TECHNICAL BULLETIN
Bell Helicopter **TEXTRON**
A Subsidiary of Textron Inc.

NO 407-99-15

MODELS AFFECTED: 407

SUBJECT: **FUEL SHUTOFF VALVE CAVITY AND SHOULDER RESTRAINT INSTALLATION, IMPROVEMENT OF.**

Figure 1. AFT Passenger, Forward Facing Seat, Shoulder Restraint Doubler Installation and Frame Rework (Sheet 1)

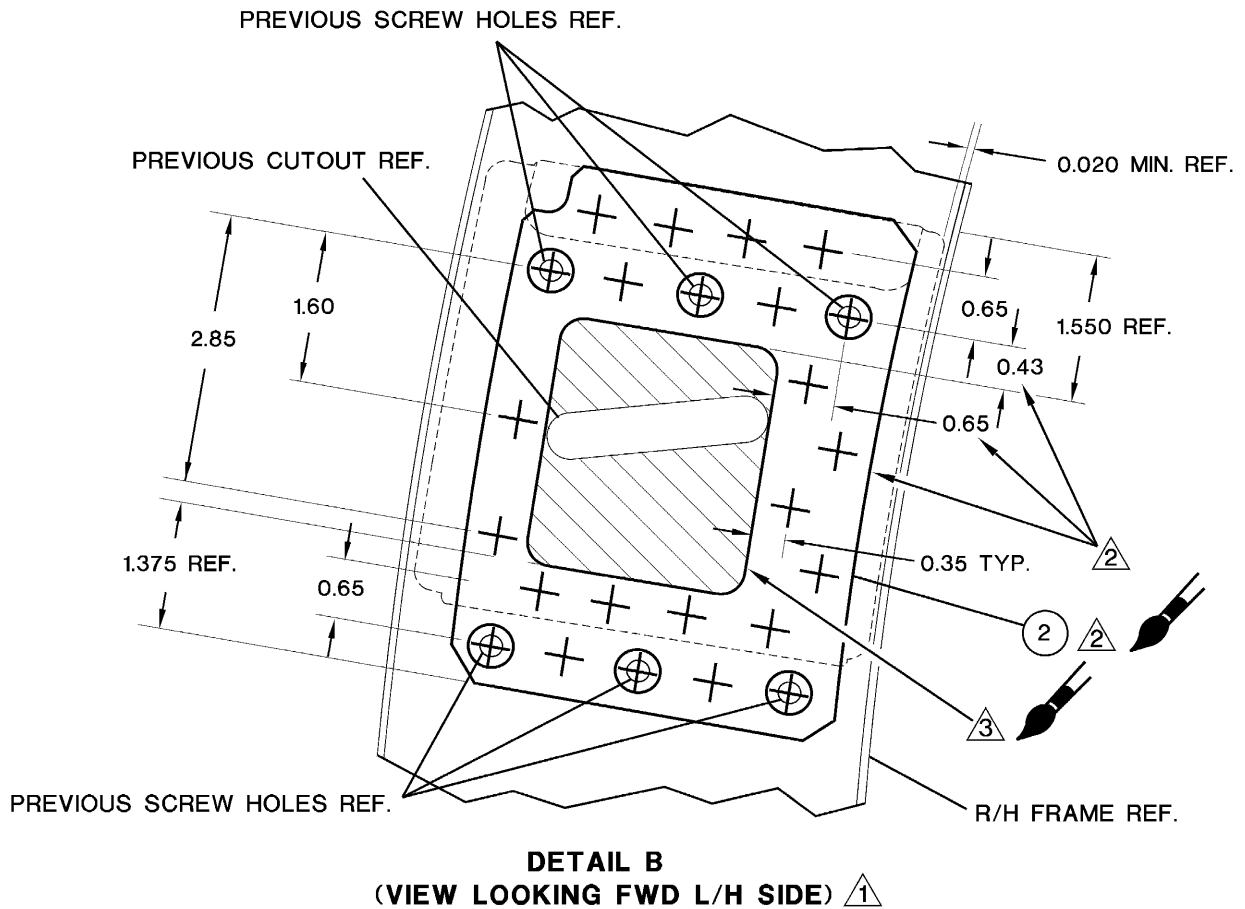
- a) Draw a line across the top of the doubler (1) at 0.43 inch parallel to the upper edge of the rectangular shaped cutout (refer to Sheets 1 and 2).
- b) Position the doubler (1) on the inner face of the frame to get correct alignment of the doubler with the existing hole cutout in the frame. Ensure that the line drawn on the doubler (1), in Step a), aligns with the center of all three top screw holes.
 - I) Temporarily secure the doubler (1) to the frame.
 - II) Transfer all (six) screw holes 0.205/0.208 inch diameter from the frame to the doubler (1).

- c) Remove the doubler (1) from the frame. Drill eighteen 0.125 inch diameter holes in the doubler at the location shown on Details A and B.
 - d) For correct alignment, use the six holes drilled in Step b to temporarily install the doubler (1) on the forward face of the frame.

- I) Use the doubler as a template, and a felt pen or grease pencil to draw rectangular shape hole on the forward face of the frame.
 - II) Transfer the eighteen 0.125 inch diameter holes from the doubler (1) to the frame.

- III) Remove the doubler (1). Deburr all holes in the frame and the doubler (1).
7. Enlarge the existing hole in the frame to match the shape drawn in Step 6.d)I):

Figure 1. AFT Passenger, Forward Facing Seat, Shoulder Restraint Doubler and Frame Rework (Sheet 2)

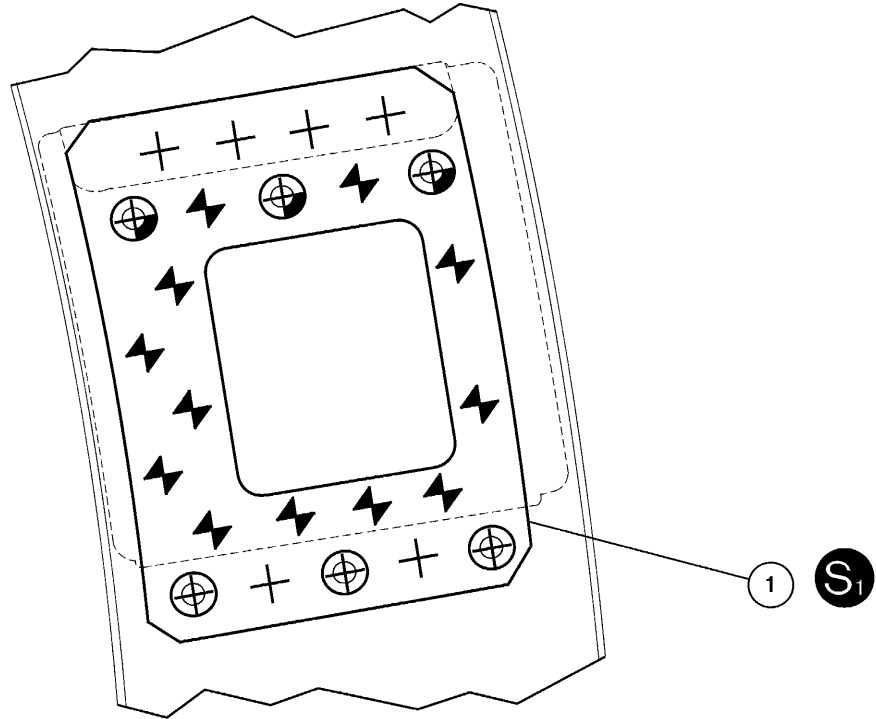
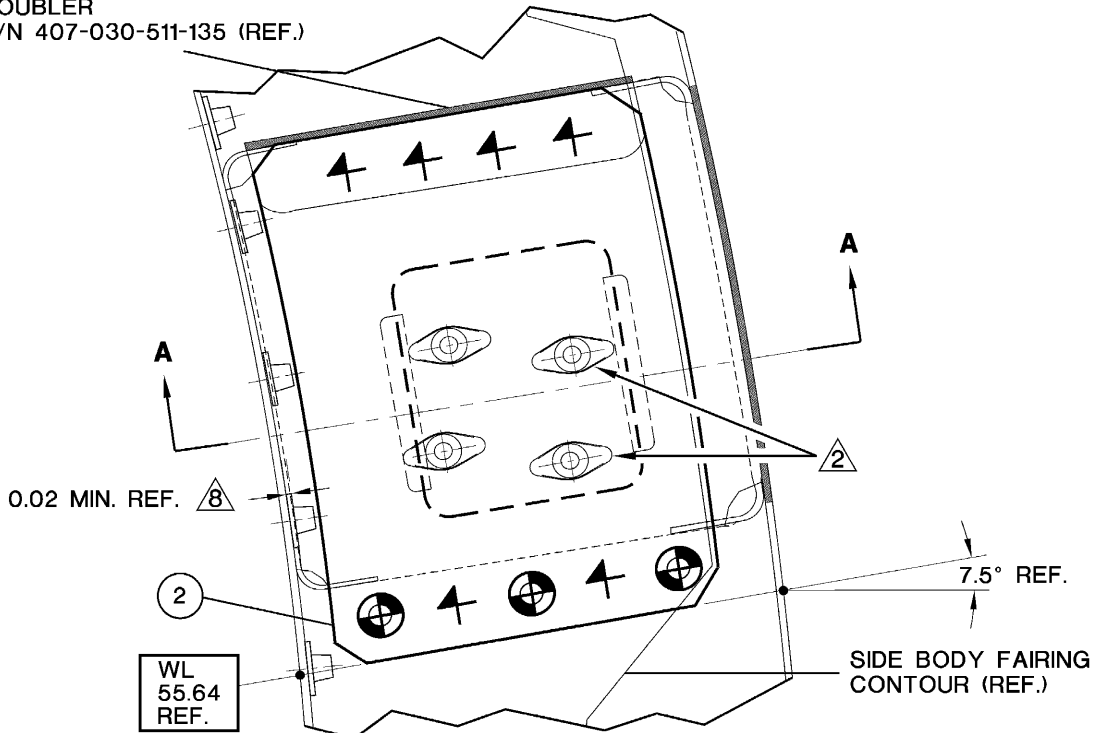
- c) Seal around the edges of the doubler and coat all the rivets with the sealant (C-308) as shown on Sheet 2.
9. Prepare the bracket assembly (2) for the installation as follows (refer to Figure 2):

- a) Put the new bracket assembly (2) on the aft face of the doubler (1). Make sure you keep a gap of approximately 0.020 inch minimum between the inboard side of the bracket assembly (2) and the inboard flange of the frame (see Sheet 2).

FIGURE 2. AFT Passenger, Forward Facing Seat, Shoulder Restraint Doubler and Bracket Assembly Installation (Sheet 1)

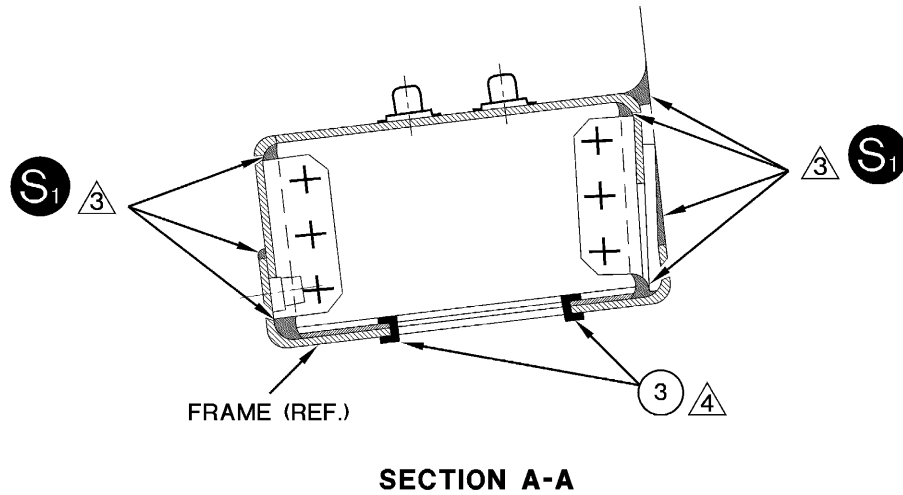
8. Install the doubler (1) on the aft face of the frame as follows (refer to Figure 2):
- a) Apply the sealant (C-308) to the surface of the doubler (1) common with the frame.

- b) Use the three rivets, M7885/6-6-03, and twelve rivets, MS20470AD4-4-5, wet with sealant to install the doubler (1) on the aft face of the frame. Do not install the rivets common to the bracket assembly (2) at this time.

- d) Remove the bracket (2) and deburr all the holes. Restore the surface finish as necessary (C-100 & C-204).
10. Install the bracket assembly (2) to the frame as follows (refer to Figure 2):

- a) Apply layer of sealant (C-308) to the top and bottom attachment flanges of the bracket (2).
 - b) Apply a thick layer of sealant (C-308) to the periphery of the bracket (2). Pay attention to the lower corners of the bracket (2).

- c) Put the bracket (2) against the aft face of doubler.
 - d) Temporarily attach the bracket (2) to the aft face of the frame/doubler assembly and proceed as follows:

- I) Seal around periphery of the bracket (2) and the doubler (1) with sealant (C-308).
 - II) Examine for voids in the sealant. If a void exists, remove the bracket and repeat Steps 9a) and 9b) as necessary until sufficient sealing of the bracket is obtained.

- e) Use the three rivets, M7885/6-6-04, and the two rivets, MS20470AD4-6, wet with sealant (C-308) to attach the bottom flange of the bracket (2).
 - f) Use the four rivets, MS20470AD4-6, wet with sealant (C-308) to attach the top flange of the bracket (2).

- g) Apply a layer of (C-308) on all the dome nuts and the rivets to make sure you get complete sealing of the fuel valve cavity.
 - h) Let the sealant cure.

Figure 3. Replacement of Flex Hose, Fuel Shutoff Valve Outlet Line

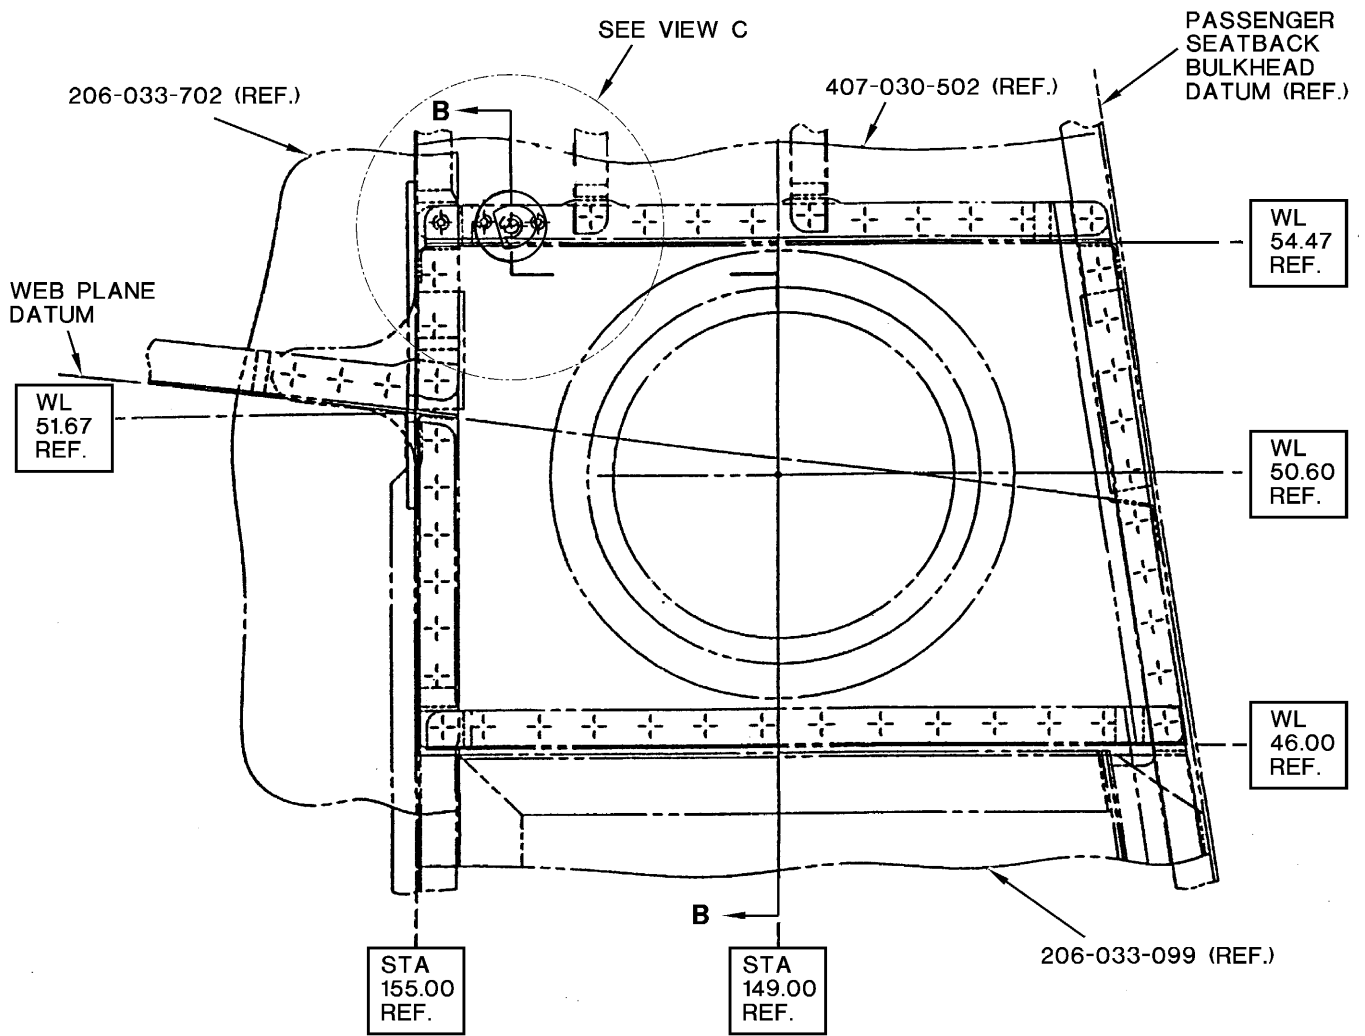
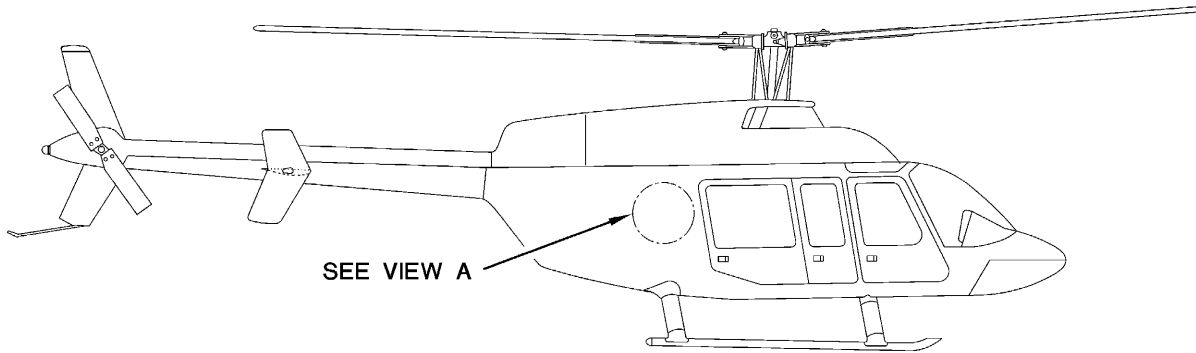
1. Get access to the fuel shut-off valve (refer to Maintenance Manual, Chapter 28, Paragraph 28-76).
2. Disconnect, remove, and discard the existing hose, 70-080H000V043 (item 4, Figure 3), from the fuel outlet port of the valve (2) and the rigid tube.
3. Install the new longer hose, 70-080H000V045, to the fuel outlet port of the valve (2) and the rigid tube.

△ Remove hose 70-080H000V043 and install hose 70-080H000V045.

Figure 4. Addition of Drain to Fuel Shutoff Valve Cavity (Sheet 1)

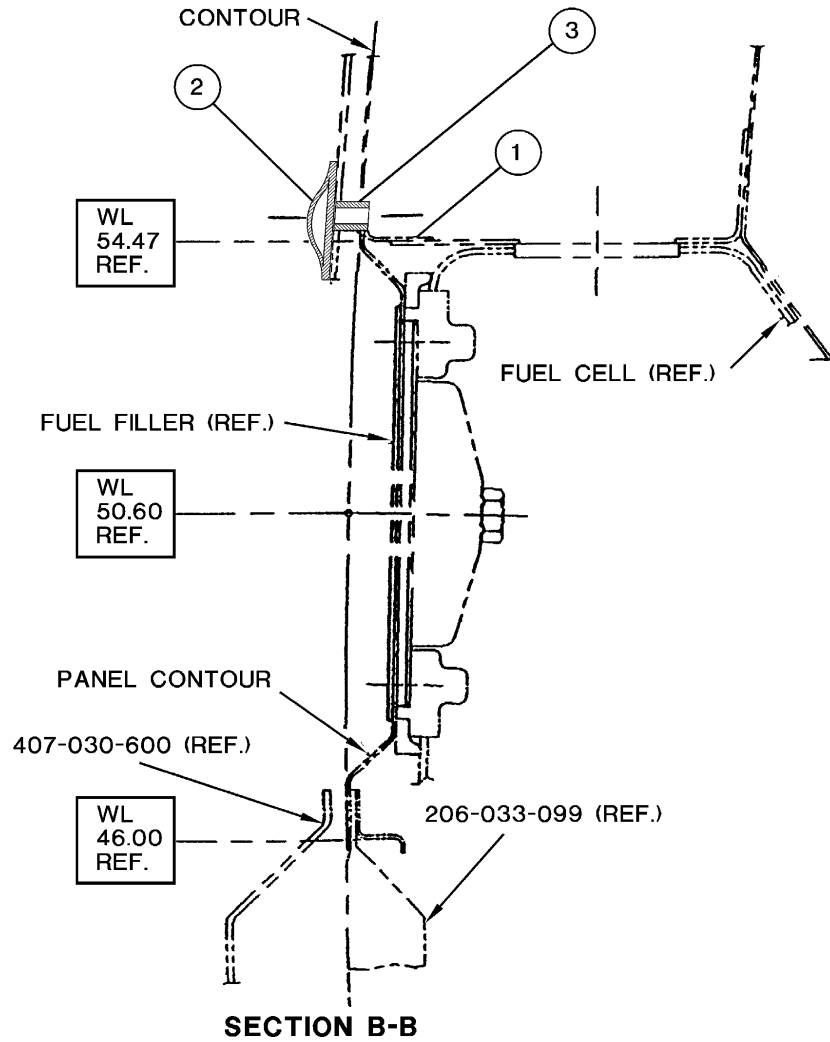
2. Drill the drain hole provision through the fuel shut-off valve cavity and the side-body fairing as follows (refer to Figure 4):

- a) Find and drill a #40 size pilot hole through the bottom stiffener, 407-030-507-123, found at the bottom of the fuel shut-off valve cavity. Make sure your drill is between level position and 1.5 degrees down. Keep drilling beyond the stiffener, through the side-body fairing assembly.

- b) From the inside of the fuel shut-off cavity, gradually enlarge the hole in the stiffener only to the final dimension of 0.375 inch diameter.
 - I) Deburr the hole.

- II) Alodine treat (C-100) and prime (C-204) all bare metal surfaces.
 - c) From the outside surface of the side-body fairing, use a cobalt drill bit to gradually enlarge the hole to the final dimension of 0.375 inch diameter.

**Figure 4. Addition of Drain to Fuel Shutoff Valve
Cavity (Sheet 2)**

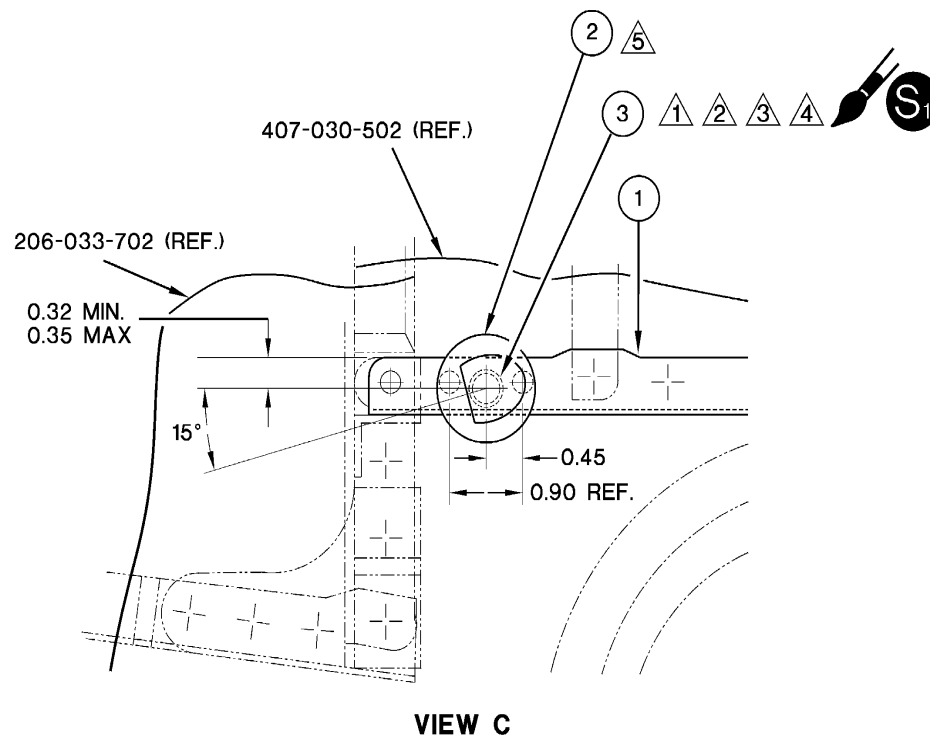
- I) Examine the edge of hole after drilling to make sure that the laminate is not damaged.
 - II) Seal the edge of the hole with the sealant (C-308).
3. Install the transfer tube (3) between the fuel shut-off valve cavity and the side body fairing as follows (refer to Figure 4):

- a) Use a 400 grit sandpaper to sand the outside surface of the nylon tubing (3).
 - b) Apply a layer of sealant (C308) to the outside surface of the tube (3) and insert the tube through the stiffener.

- c) Align the tube with the hole through the side body fairing and push the tube until it protrudes to the exterior.
 - d) Cut the ends flush or within 0.03 inch of protrusion maximum with the stiffener and the outside skin surface.

- e) Examine for voids in the sealant around both ends of the tube (3). Touch-up the sealant as needed.
4. Install the drain grommet (2) on the surface of the fairing, over the new hole. Use adhesive (C-311), and let cure.

5. Ensure the flat edge of the grommet is offset with the vertical plane as shown in Figure 4.

- 1. Drill 0.375 hole through stiffener (inner structure) and external skin (side-body fairing). Seal edges of holes with sealant (C-308).
- 2. Length of tube shall be determined at installation. Put a light layer of adhesive on the exterior surface of tube and put it through the hole in stiffener and the fairing while sealant is still wet. Trim both ends of the tube to be flush or within 0.03 protrusion from inboard structure and outside skin.
- 3. Nylon tubing must be securely fastened and form a complete seal to inboard structure and outside skin using sealant (C-308).
- 4. Make sure hole clears inboard structure bend radius.
- 5. Use adhesive (C-311) and bond grommet AN231-4 to external skin surface. Paint grommet to match exterior paint colours.
- 6. All dimensions are in inches.

Figure 5. Fuel Cells Interconnect Line, Improved Seal/Washers Installation

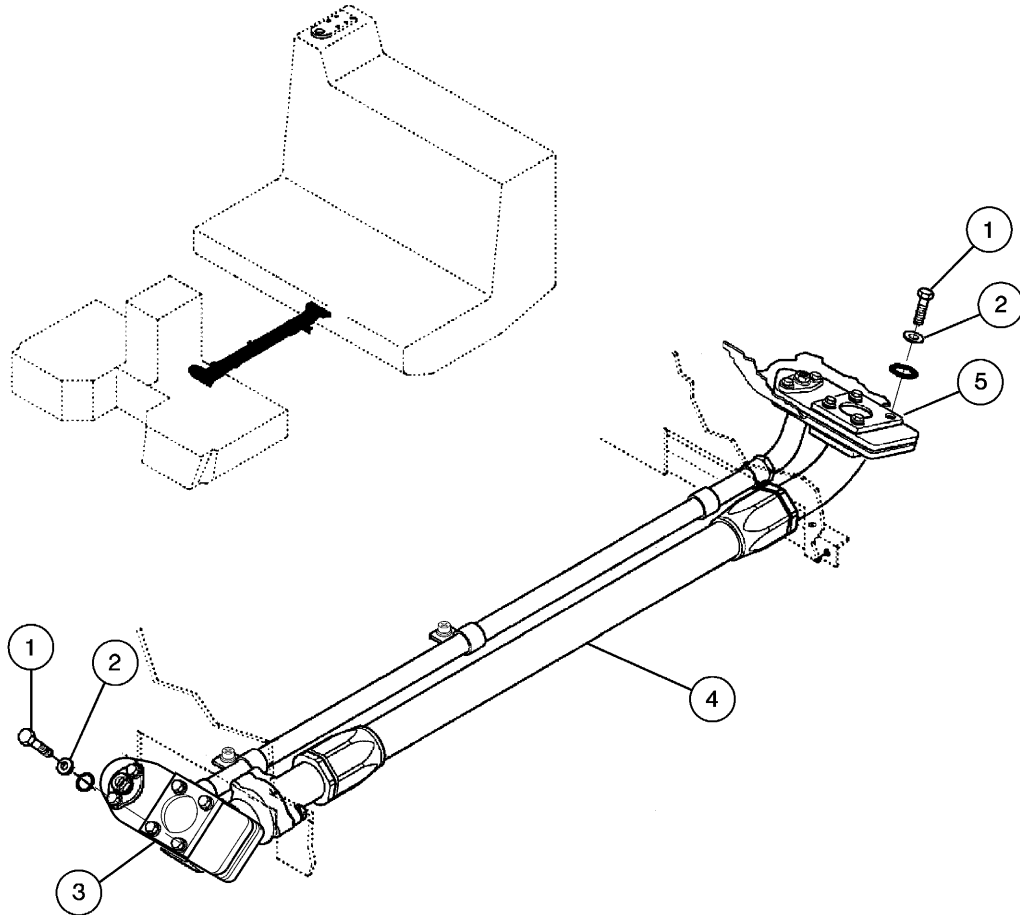
1. Defuel the aircraft (refer to Maintenance Manual, Chapter 28, Paragraph 12-9).
2. Proceed as follows (refer to Maintenance Manual, Chapter 28, Paragraph 28-32 and Figure 5) to remove the fuel transfer pump assembly from the forward fuel cell to get access to the forward end of transfer hose (4).

- a) At the forward flange retainer (3), remove one bolt (1) at a time that attaches the forward end of the hose (4) and replace existing washer with the new seal/washer (2).

- b) Install the bolt (1).
 - c) Repeat the Steps 2a) and 2b) for the remaining three bolts (1) that attach the forward retainer (3).
3. Remove the fuel boost pump assembly from the main fuel cell to get access to the aft end of the transfer hose (4). Proceed as follows (refer to the Maintenance Manual, Chapter 28, Paragraph 28-51 and Figure 5):

- a) At the aft flange retainer (5), remove one bolt (1) at a time that attaches the aft end of the hose (4) and replace the existing washer with the new seal/washer (2).

- b) Install the bolt (1).
 - c) Repeat the Steps 2a) and 2b) for the remaining three bolts (1) that attach the aft flange retainer (5).
4. Install the fuel transfer pump assembly (refer to Maintenance Manual, Chapter 28, Paragraph 28-34).

Remove the bolts one at a time and replace the existing washer, NAS1149D0416K under the head of the bolt by washer, NAS1523AA4R (8 places).
